Manitoba Hydro

Pointe du Bois Spillway Replacement

Alteration

August 2012

Figure:
3.6
Rev 1

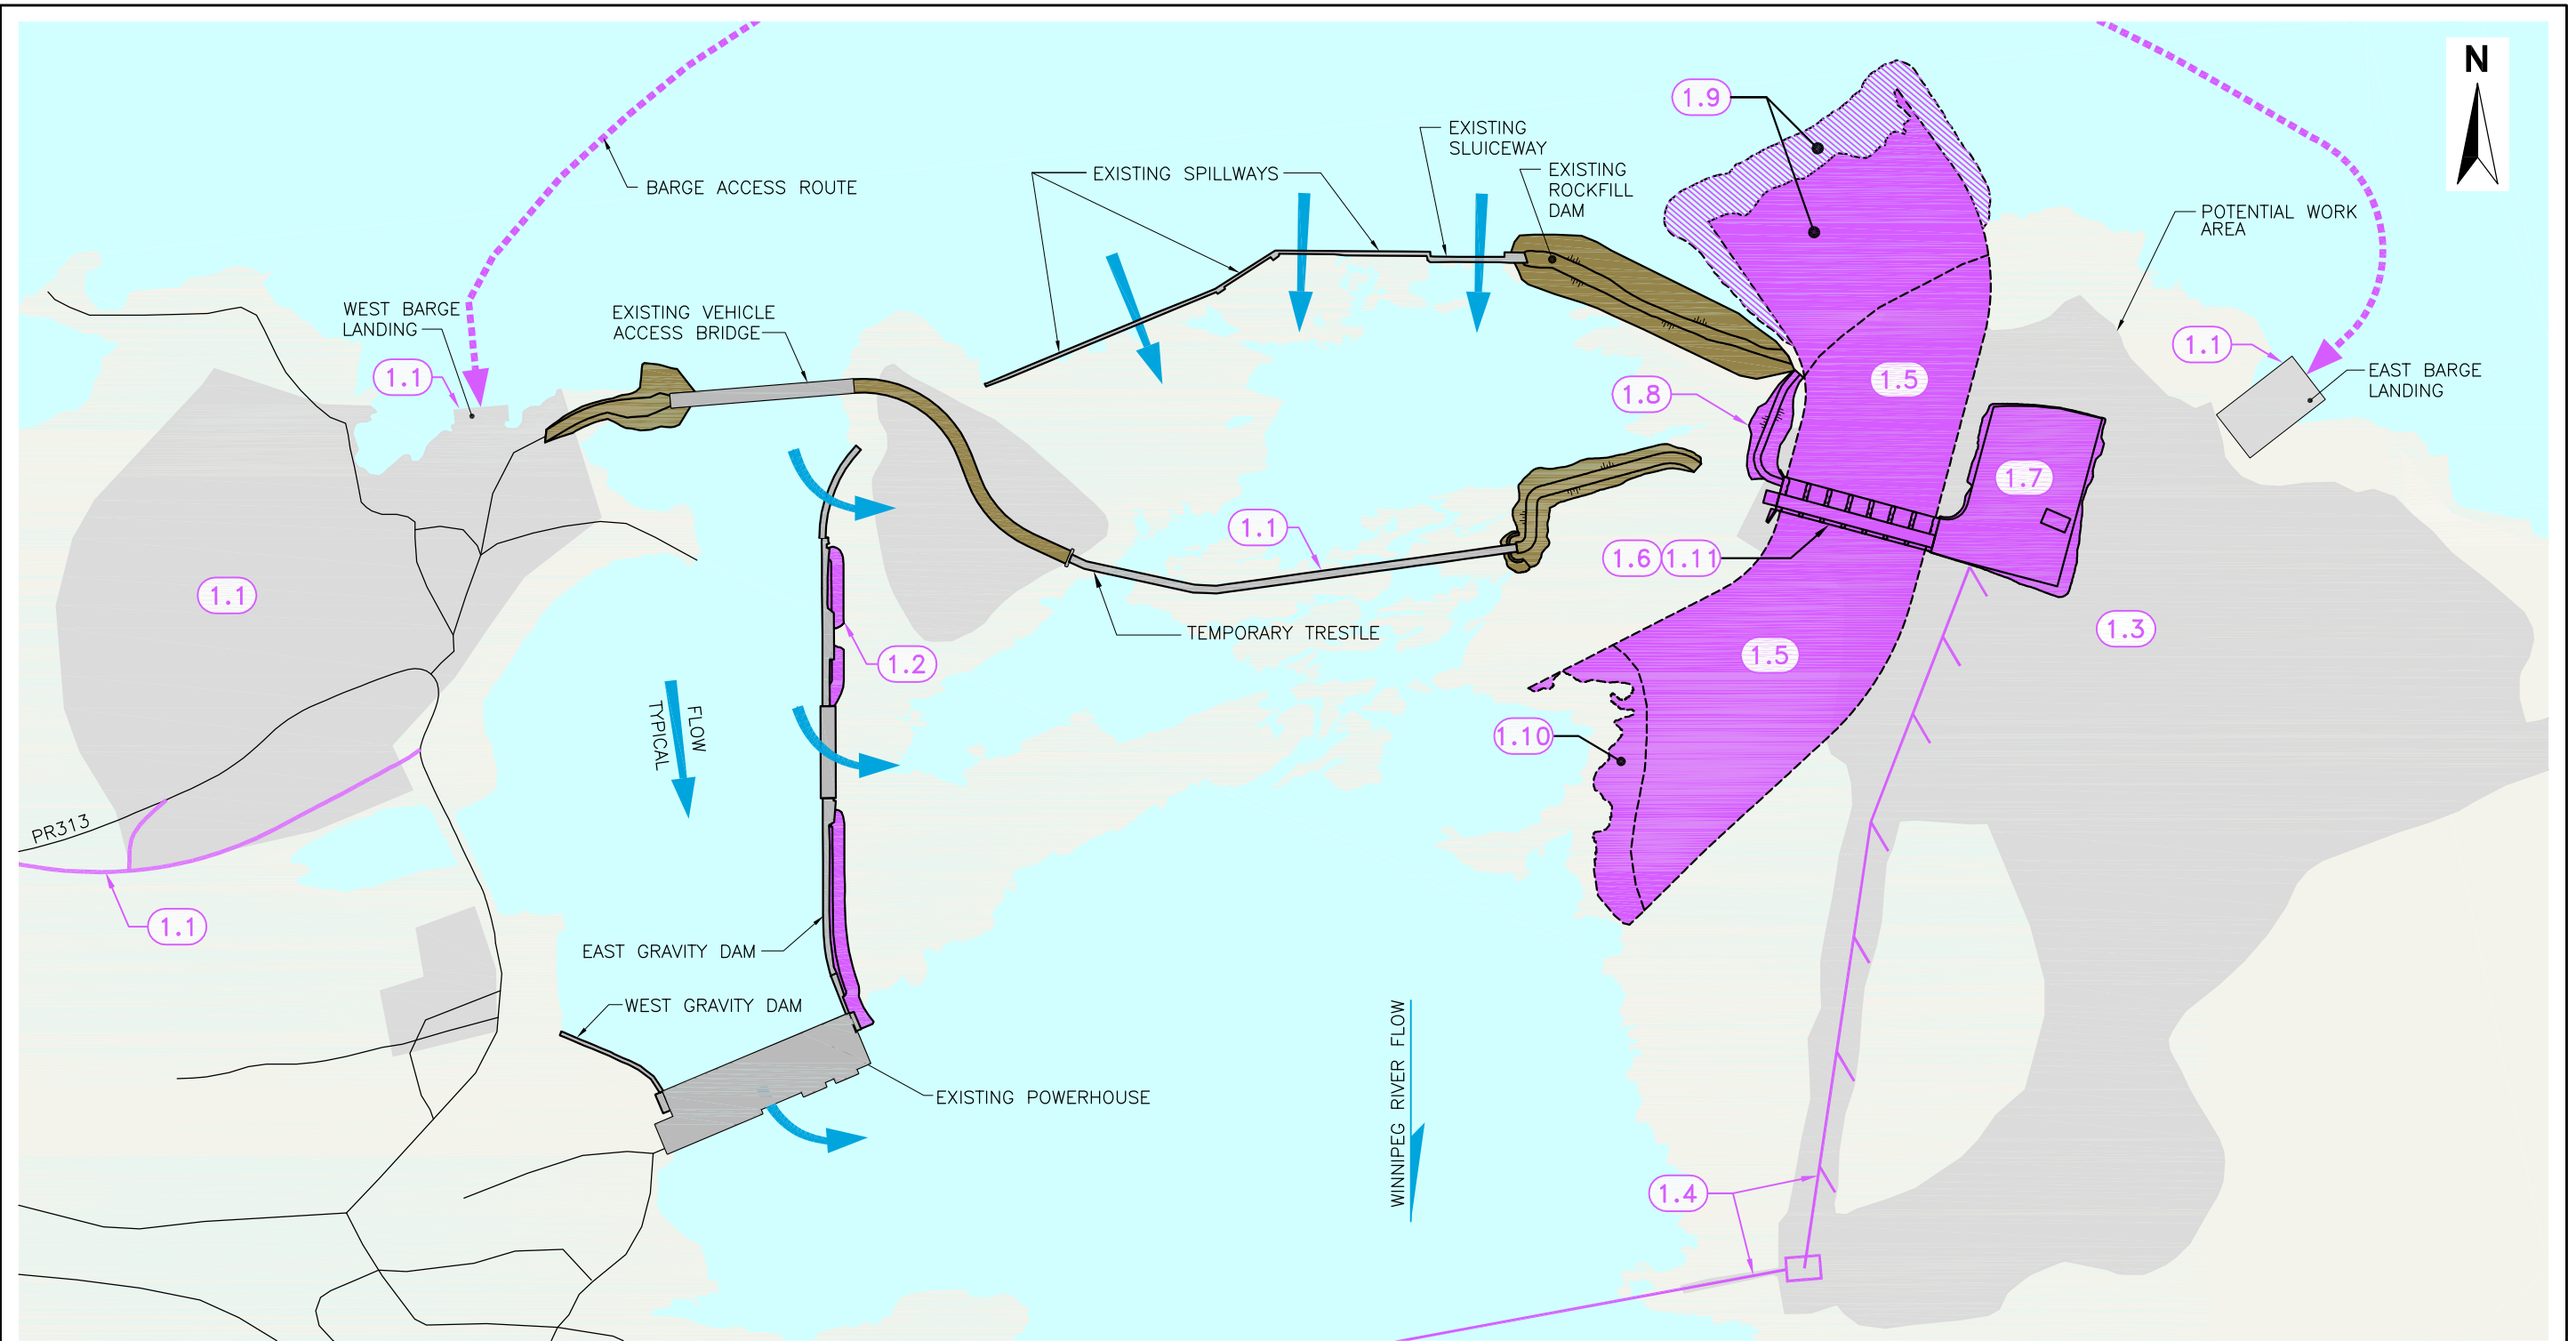
A summary schedule of the project stages is outlined in Figure 3.6 Rev1 and the general activities associated with each stage of the project are described below. These stages identify the anticipated but approximate durations associated with the various construction activities. Manitoba Hydro and the contractor may identify opportunities to reduce this schedule during detailed design and construction.

Pointe du Bois Spillway Replacement Project	
STAGE 2 Construction, Decommissioning & Rehabilitation	
Figure: 3.7B	Rev 1

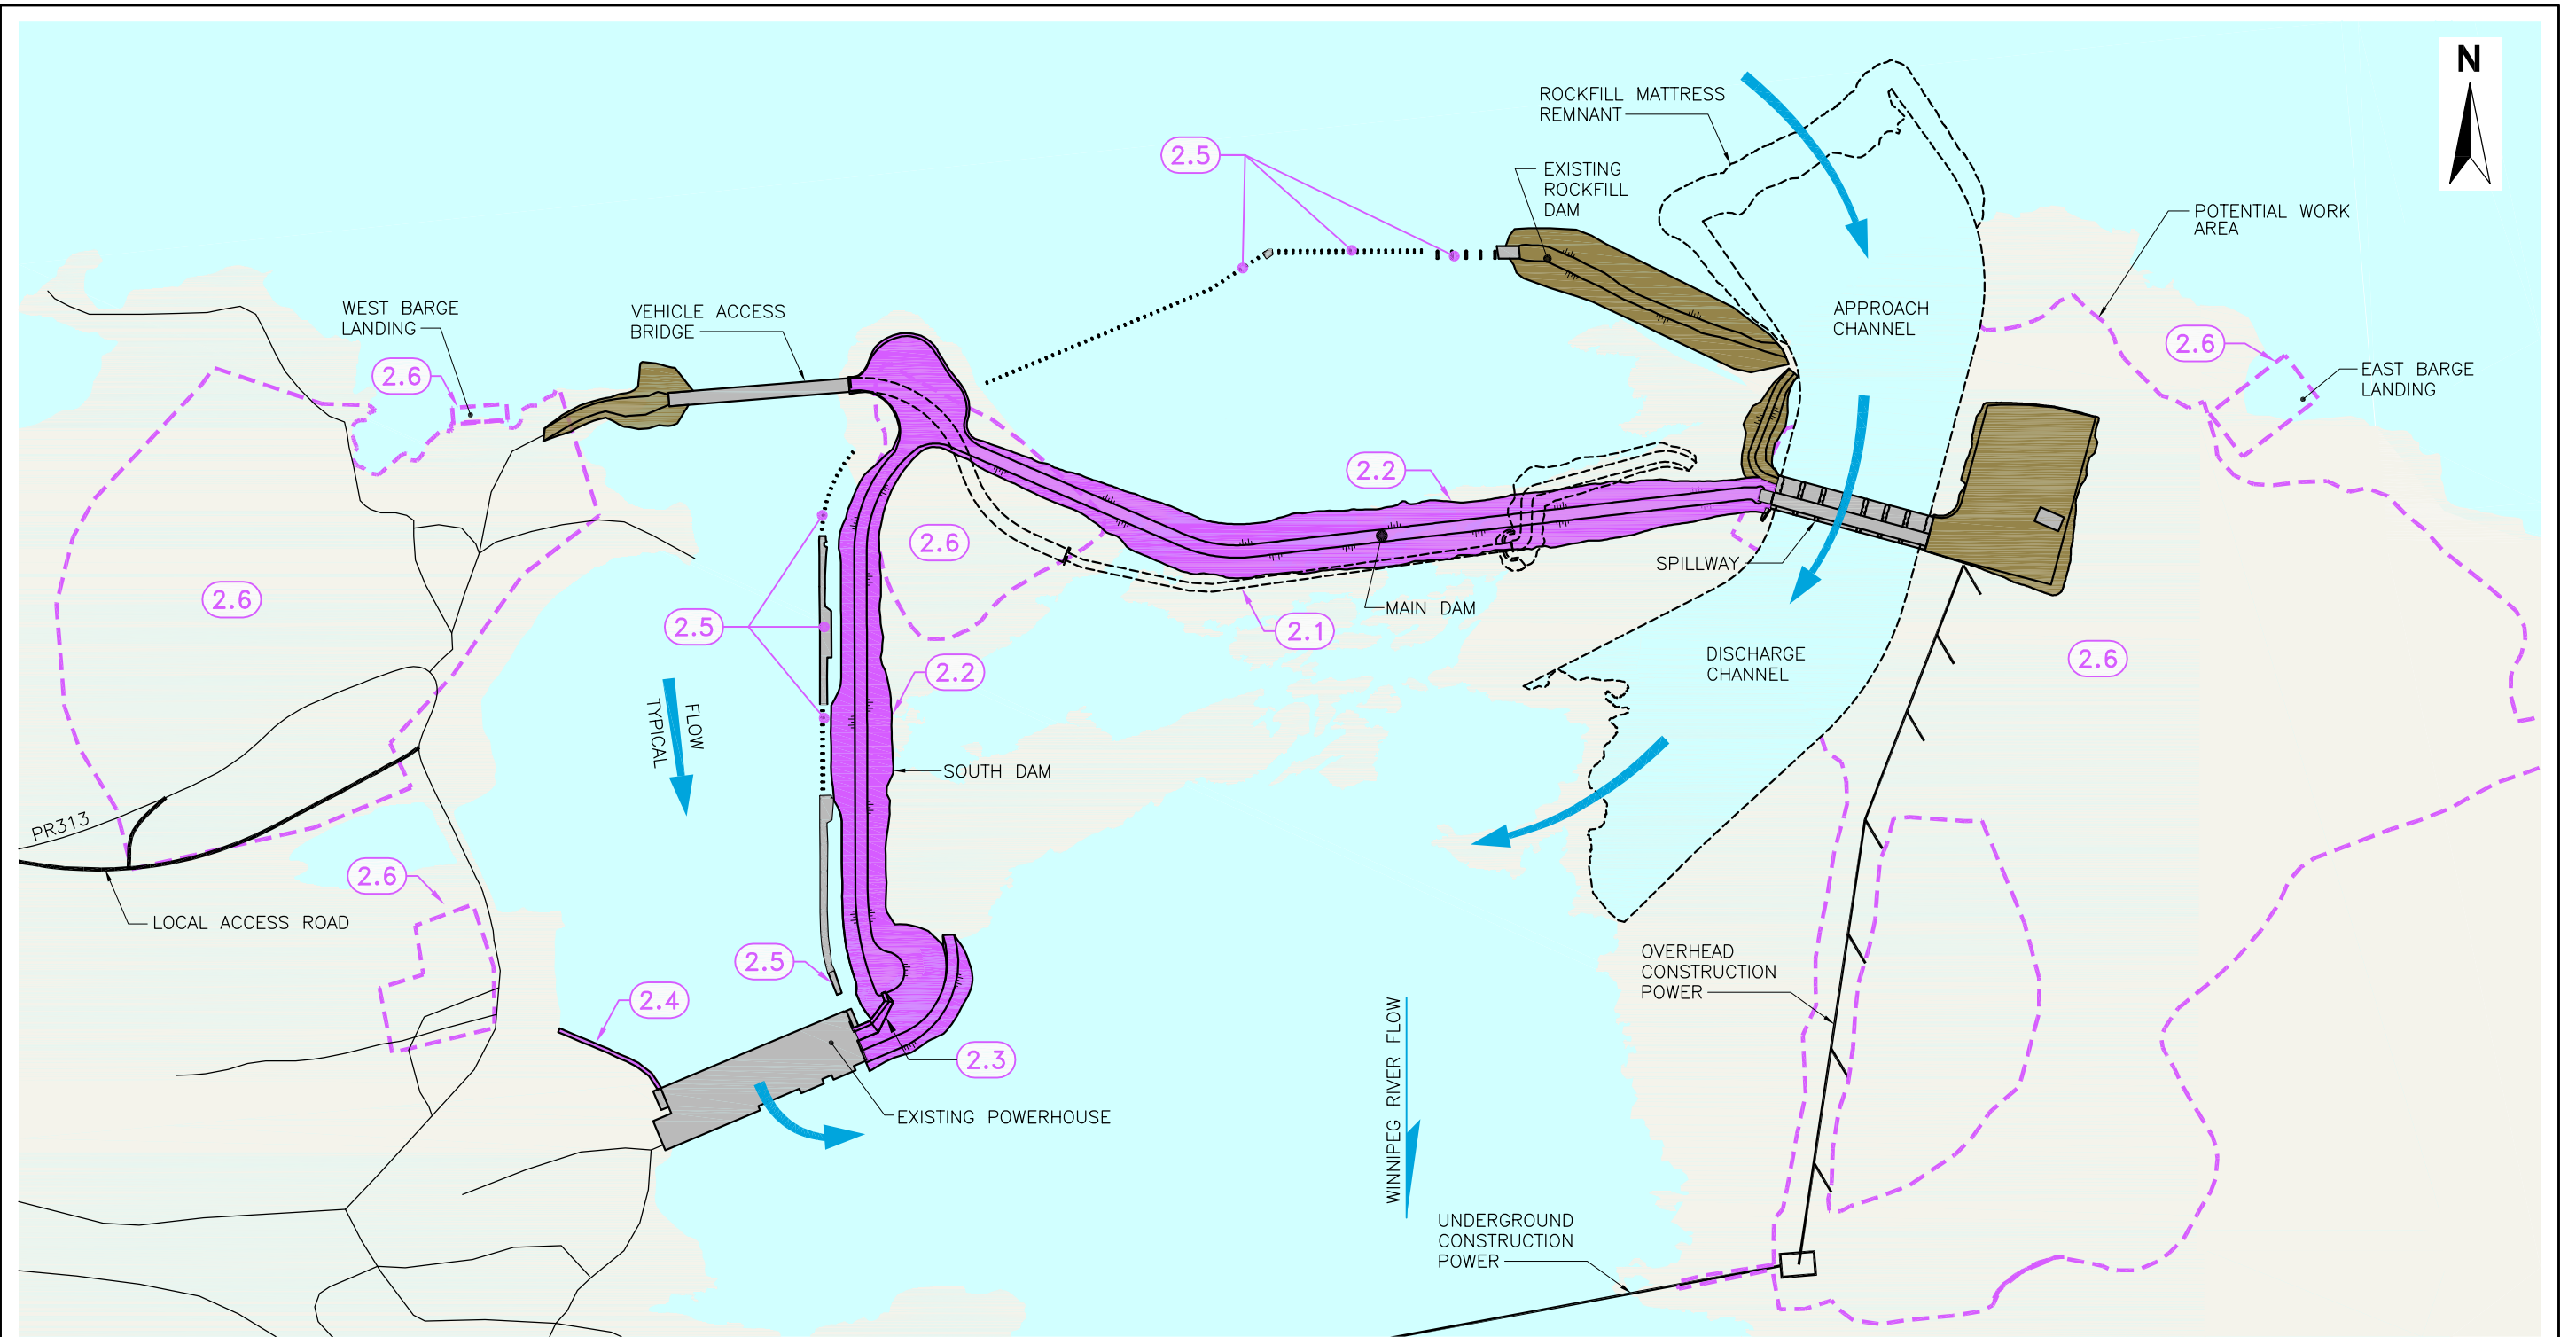
Figure 3.7B Rev1 illustrates the components of Stage II construction that will occur following commissioning of the spillway.

Construction of earthfill dams will occur as described with the Original Arrangement. An exception is the installation of a box culvert below the main earthfill dam. During construction of the main dam, this culvert will manage seepage water from the existing structure and rock fill dam. The box culvert will be placed at the desired elevation to maintain the consistent water levels in the upstream pond and to dry the footprint of the main earthfill dam work area. After completion of the main earthfill dam, the box culvert will be grouted closed. Construction of the powerhouse east abutment cofferdam will occur as described with the Original Arrangement.

Figure:
3.19
Rev 1

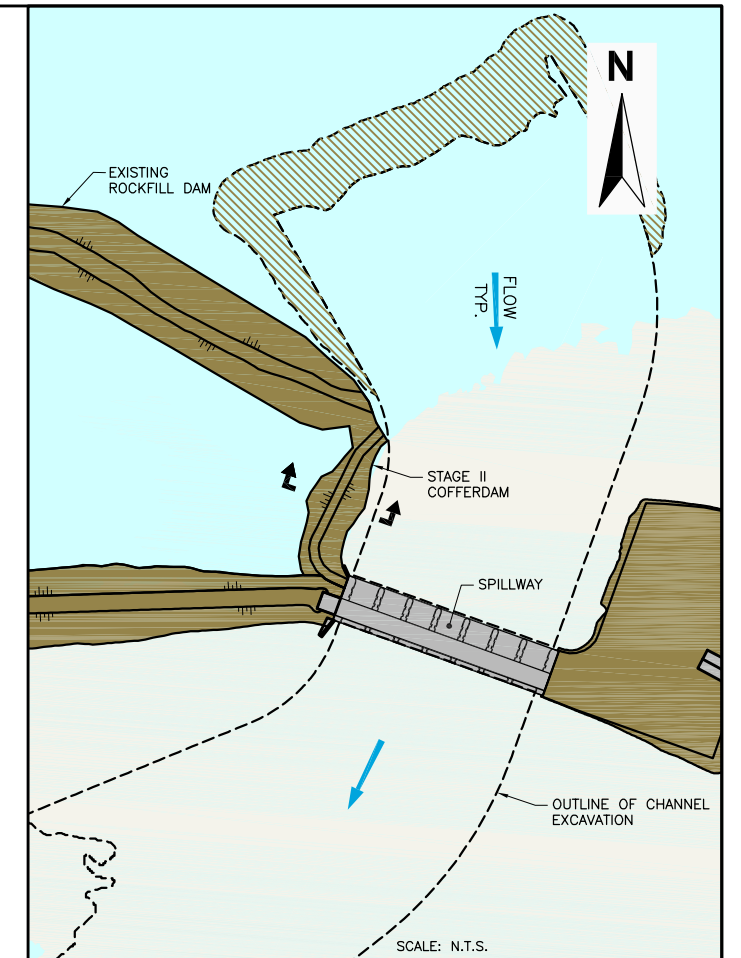
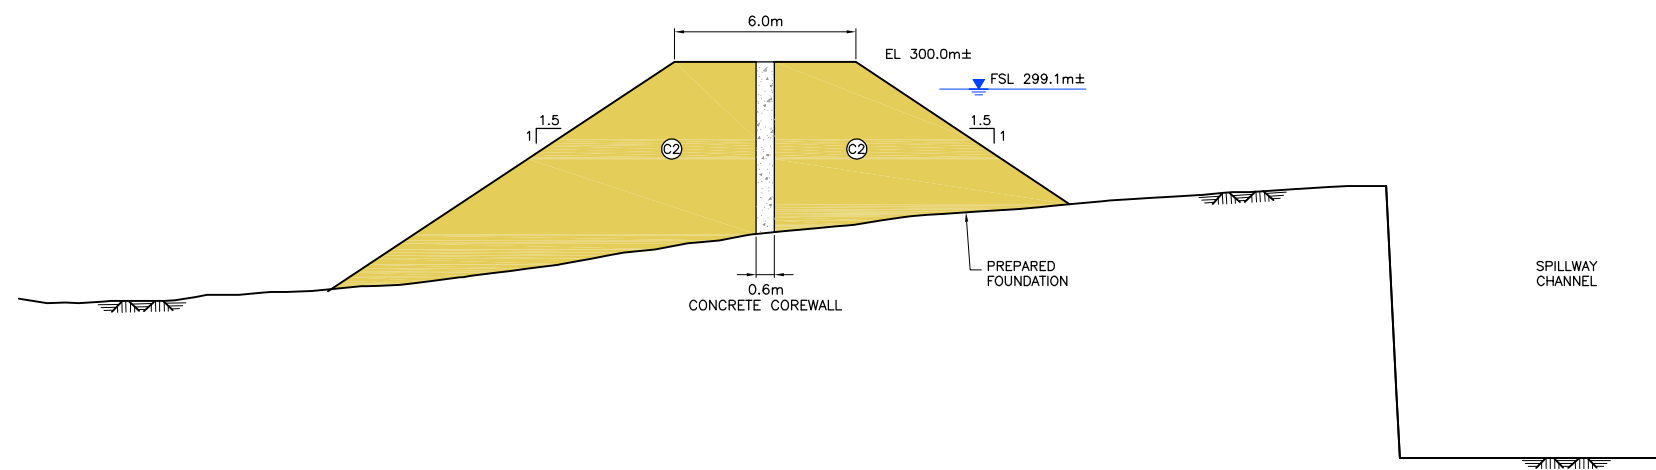
Approach and discharge channels will serve to direct water flow into and out of the new spillway structure. The approach channel will be approximately 230 m in length and 126 m in width. The discharge channel will be approximately 340 m in length and 126 m in width, flaring towards the exit. The approach channel will be excavated to an approximate elevation of 287.0 m immediately upstream of the spillway structure and transition to 290.0 m at the upstream end (Figure 3.19 Rev1).

Figure:
3.20
Rev 1

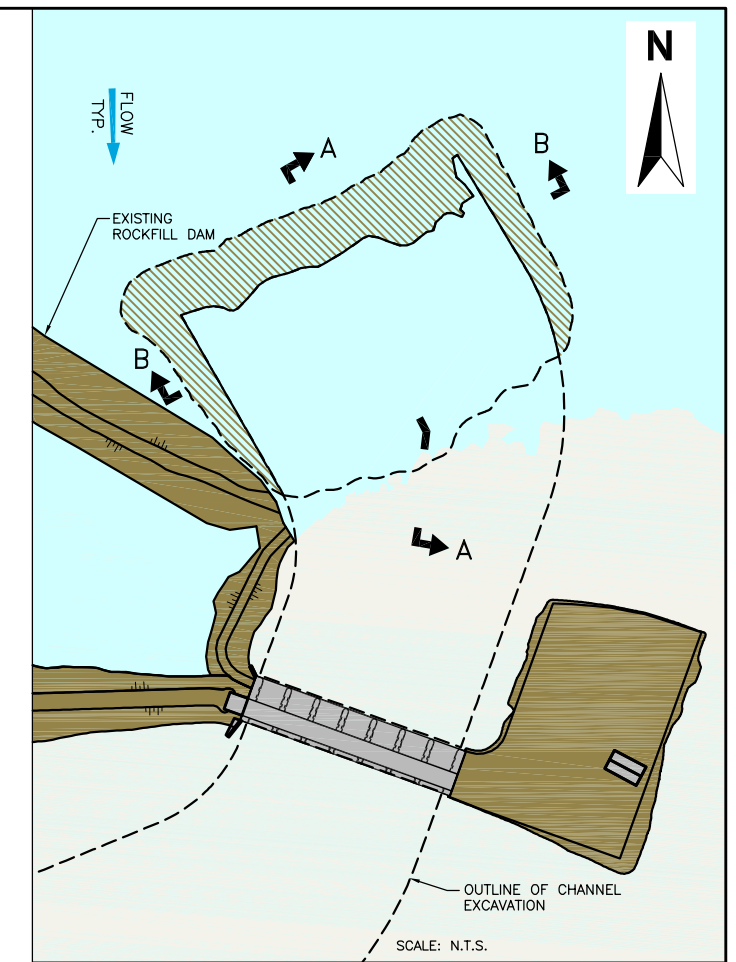
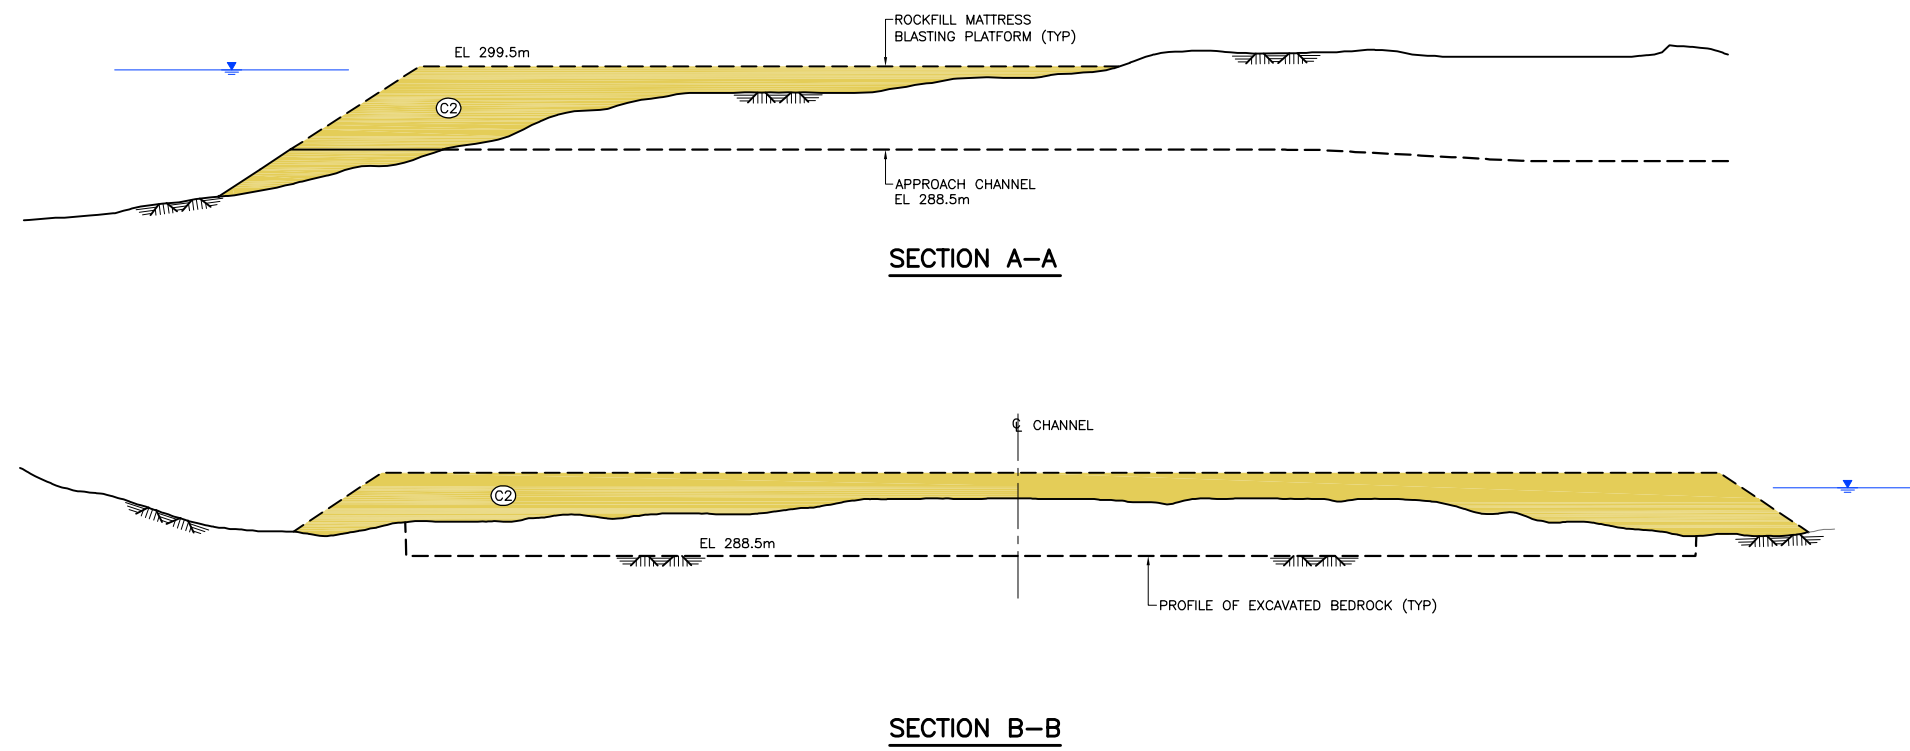
The Stage II cofferdam will provide a water tight seal to protect the earthfill dam construction while the new spillway is in service. It will be of concrete core construction and will be built in the dry prior to watering up the approach channel (Figure 3.20 Rev1). This cofferdam will not be removed.
